SERVICE BULLETIN MAINTENANCE OF WAY EQUIPMENT											
DATE:	4-18-2006	BULLETIN NO:	06-004								
TITLE:	SOLID STATE STARTER RELAY I	SSUES AND CONVERSION GROUP									
RATING:	DIRECTIVE (Action Is Required)	X ALERT (Potential Problem)									
	INFORMATION (Action Is Optional)	PRODUCT IMPROVEMENT (Enhance Product)									
PRODUCT SE	ERIES / MODEL: 6700S or J Tamp	pers with or without Jupiter									
SERIAL NO:	Models #153245 through #153388										
SUMMARY:	Starter Relay, part #2004579. Upor manufacturer had made a change t	e rate occurring on the existing Solid Sol	ngine nis								
	•	the existing solid state starter relay wi

CONVERSION GROUP INSTALLATION INSTRUCTIONS

CADAM DRAWING

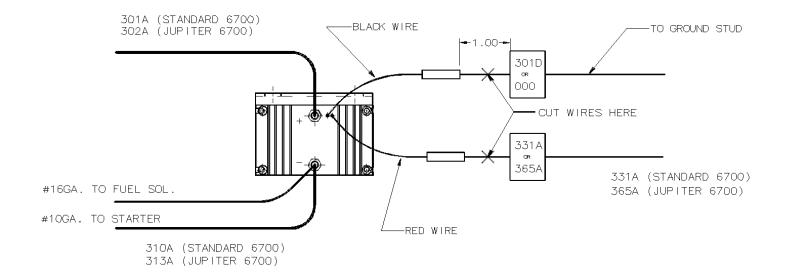
SOLID STATE RELAY REMOVAL REMOVING THE WIRING:

- INSURE THAT THE BATTERY SWITCH IS TURNED OFF.
- LABEL THE CONTROL WIRES 301D AND 331A (OR 000 AND 365A FOR JUPITER 6700S') JUST ABOVE THE ORIGINAL BUTT SPLICES. SEE DIAGRAM.
- CUT THE CONTROL WIRES BETWEEN THE LABEL AND THE ORIGINAL BUTT SPLICES.
- REMOVE THE #10GA. WIRE, 301A (302A FOR JUPITER 6700S') FROM THE (+) TERMINAL OF THE SOLID STATE RELAY.
- REMOVE BOTH THE #10GA. AND #16GA. WIRES, 310A (313A FOR JUPITER 6700S') FROM THE (-) TERMINAL OF THE SOLID STATE RELAY.

REMOVING THE RELAY:

- REMOVE THE 2 BOLTS ATTACHING THE RELAY BRACKET TO THE PUMP DRIVE.
- REMOVE THE RELAY AND SHOCK MOUNTS FROM THE BRACKET AND DISCARD THEM,
- REWORK THE BRACKET AS SHOWN BELOW.
